**Engineering Support Services and Recommendations for Roadside Safety Issues or Problems  
for Member States**

Pooled Fund Program TPF-5(501)

**Engineering Opinion No. 202503**

**TDOT GUARDRAIL TRANSITION WITHOUT CURB WITH MWRSF BUTTRESS**

**Figure 1. Key Details of TDOT AGT System (Source: TDOT Standard Drawing S-GRC-4, (06-28-2019))**

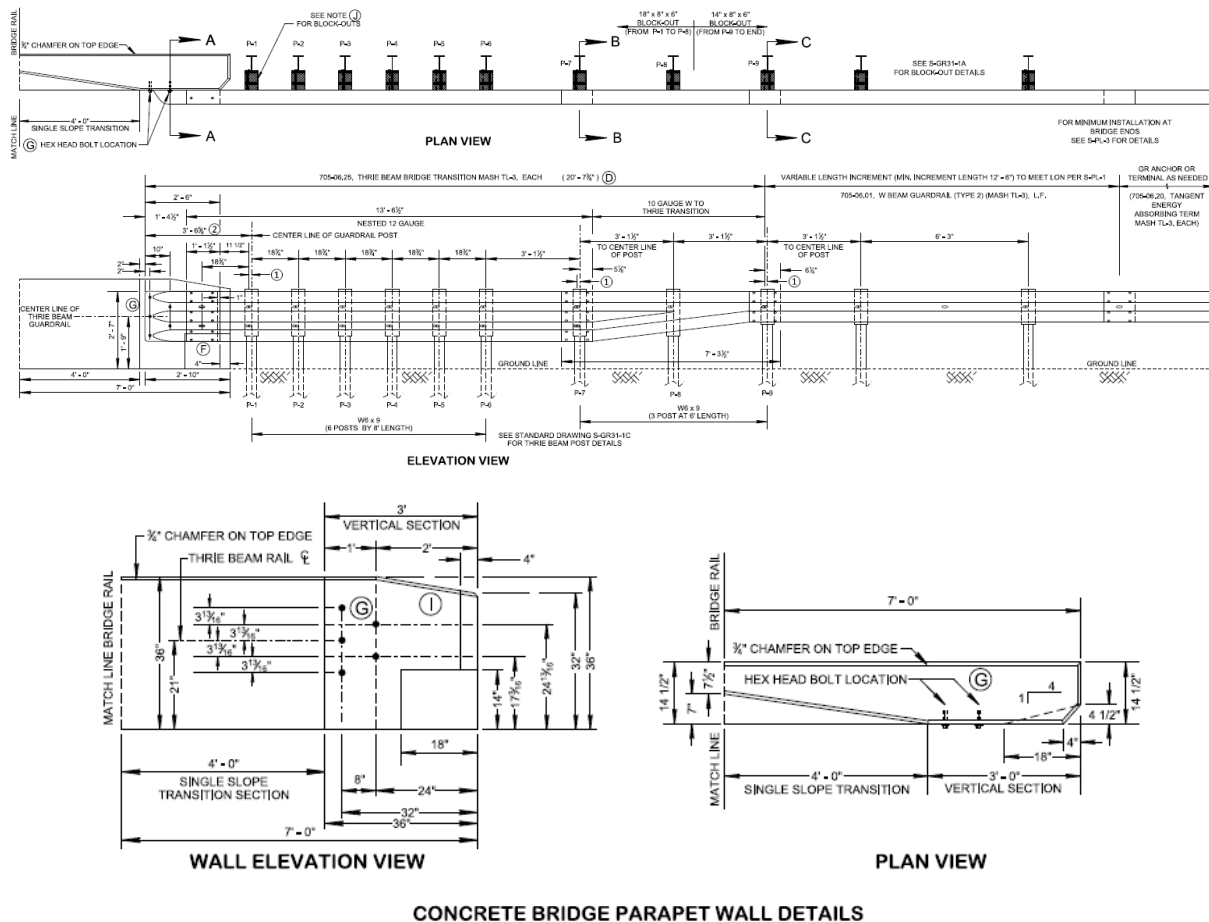
The assessed system is TDOT approach guardrail transition (AGT) attached to a concrete buttress, currently incorporated in TDOT Standard Drawing S-GRC-4 (Figure 1). It is comprised of the W-beam guardrail system transitioning to a nested thrie beam guardrail section via a shape transition section. The nested thrie beam section is then attached to the concrete buttress. The post spacing is reduced over the span of the transition such that the six posts adjacent to the concrete parapet are installed with 18.75-inch quarter post-spacing. These posts are installed with an embedment depth of 64 inches.

The specific TDOT AGT system (Figure 1) has not been crash tested. However, there are relevant past tests of similar AGT systems that can be used to assess its MASH compliance to Test-Level 3 (TL-3) of MASH.

Use of MwRSF's buttress in TDOT AGT design incorporates the two key design features of the TTI AGT's single slope parapet, i.e., tapering back the bottom edge of the concrete parapet to reduce vehicle snagging and keeping the back of the thrie beam in the vertical plane. For this reason, the replacement of TTI's single slope concrete parapet with MwRSF concrete buttress in TDOT AGT design is acceptable, and the TDOT AGT design is expected to perform similar to the TTI AGT design for MASH Test 3-21.

For guardrail transitions, MASH recommends an optional Test 3-20 with the small passenger vehicle. This test was not performed for the TTI AGT with the single slope parapet or the MwRSF AGT with the concrete buttress. However, MwRSF performed Test 3-20 with a slightly different version of concrete buttress with the top thrie beam rail height of 34 inches instead of 31 inches (3). This system passed Test 3-20. Increasing in thrie beam rail height to 34 inches results in a 3-inch increase in the space between the bottom of the thrie beam rail and the ground. This results in greater opportunity for the small car to wedge underneath the thrie beam rail and interact with the end of the concrete buttress, potentially causing increased vehicle snagging. Due to the similarities in the concrete buttress design and greater potential for small car snagging, the AGT with 34-inch rail height is more critical than the TDOT AGT design. Since the MwRSF AGT with 34-inch rail height passed Test 3-20, the TDOT AGT design is also expected to pass Test 3-20.

Based on the information presented herein, the TDOT AGT design, as presented in Figure 1 and TDOT Standard S-GRC-4, is considered MASH TL-3 compliant.

**Figure 2. Key Details of TTI AGT (2).**

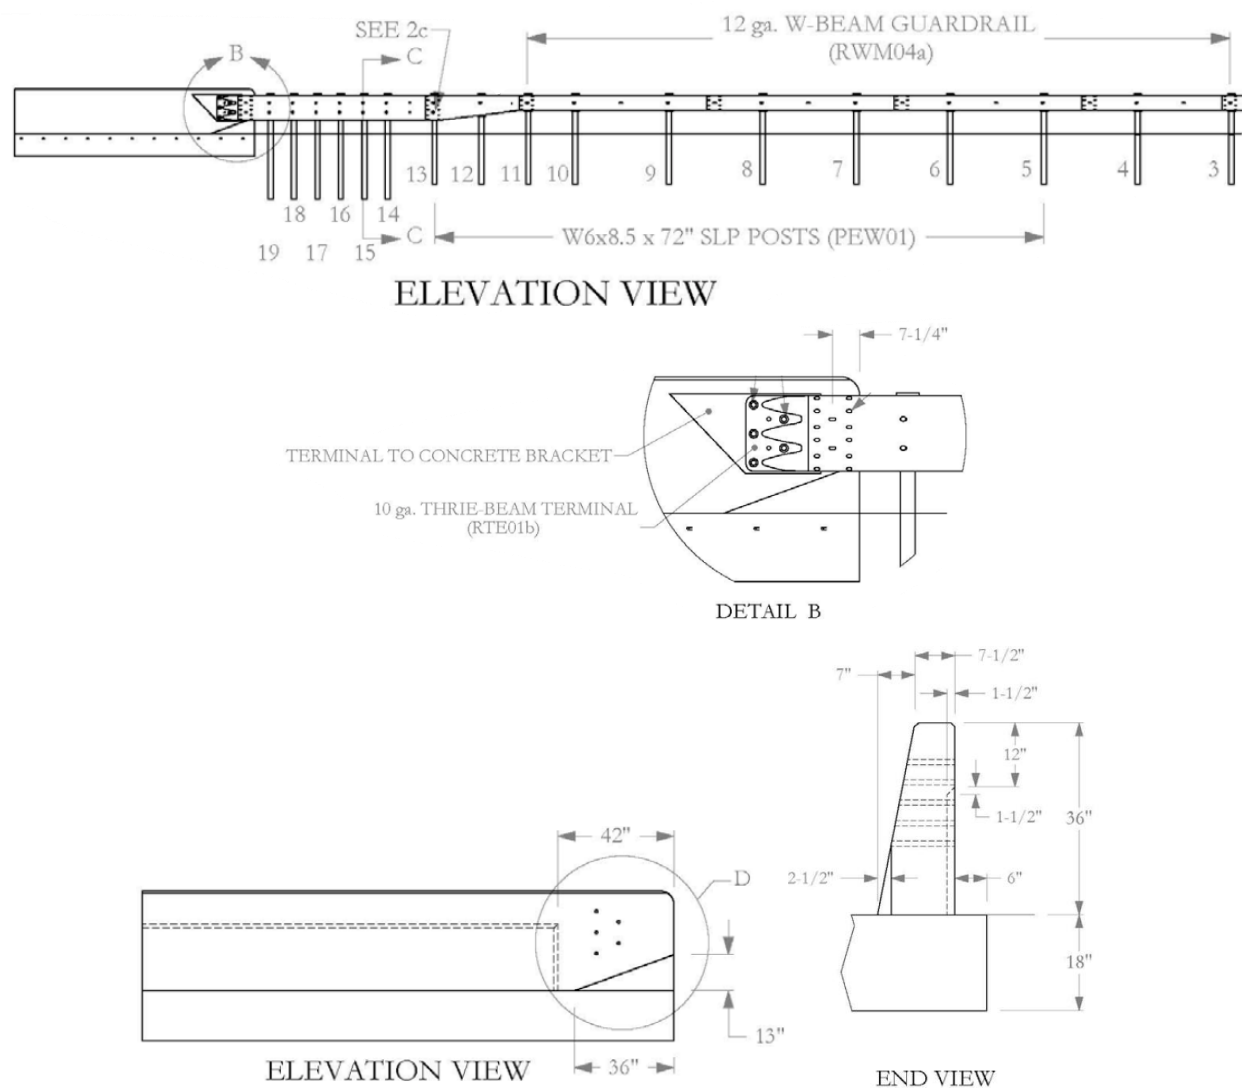
The nested thrie beam and post spacing design of TDOT AGT system is similar to an AGT system tested by Texas A&M Transportation Institute (TTI) (2). The TTI AGT system attached the nested thrie beam to a single slope rigid concrete parapet. A special steel bracket was attached to the back of the thrie beam where it connected to the single slope parapet. This bracket held the back of the nested thrie beam in the vertical plane. The TTI AGT system did not have a curb under guardrail transition. The bottom 13-inch height of the traffic-side edge of the single slope parapet adjacent to the thrie beam guardrail was tapered back 2.5 inches to prevent vehicle snagging (Figure 2).

While the TDOT AGT system uses details of the TTI AGT system described above, it does not use the single slope parapet, or the steel bracket used in the TTI design to hold the back of the thrie beam in the vertical plane. Instead, TDOT AGT uses the concrete buttress that was developed by MwRSF which has a vertical profile. The bottom traffic-side edge of the MwRSF buttress tapers back 4.5 inches to prevent snagging (1) (Figure 3).

**Figure 3. Concrete Buttress Tested by MwRSF (1).**

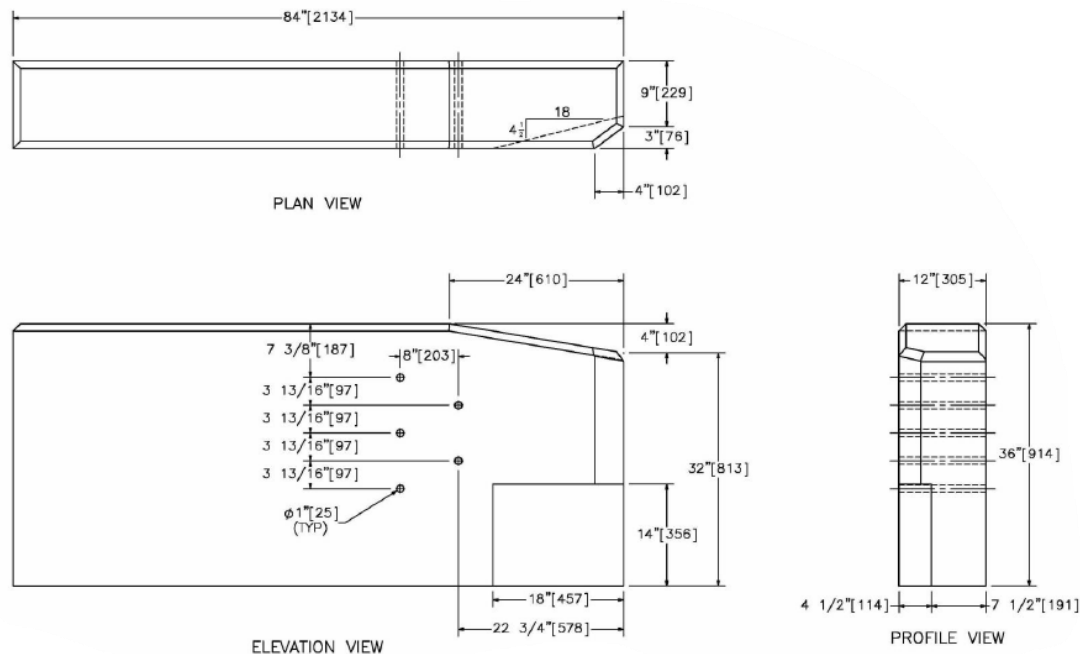
The concrete buttress is 36 inches tall with several tapers built into the design to reduce potential for snagging of an impacting vehicle with the edges of the rigid buttress. This buttress was successfully tested with an AGT design by Midwest Roadside Safety Facility (MwRSF) in MASH Test 3-21, MwRSF Test AGTB-1 (1). Bottom 14-inch height of the buttress's traffic-side edge adjacent to the thrie beam guardrail is tapered back 4.5 inches to prevent snagging of an impacting vehicle underneath the thrie beam guardrail.
